# Validation Report

VALIDATION OF THE CDM-PROJECT:  
Ouro Small Hydropower Plant – Brennand CDM Project Activity

REPORT NO. 1225732

**25 July 2012**

**Figure 1 –Exemplification of electricity generation and energy assured of a hydropower plant**

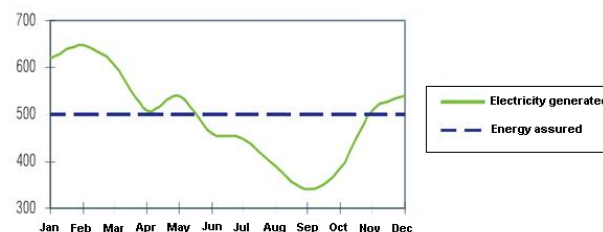
### Continuation of CAR No. 12.

According to ANEEL explanations (<http://www.aneel.gov.br/arquivos/pdf/caderno3capa.pdf>): “...the energy assured is established independently of the real electricity generation; energy assured is associated to the estimated long-term operational conditions of power plants, assuming a specific risk of electricity supply (deficit) mainly when electricity generation is related to hydrologic variability whose hydropower plants are subjected to”.
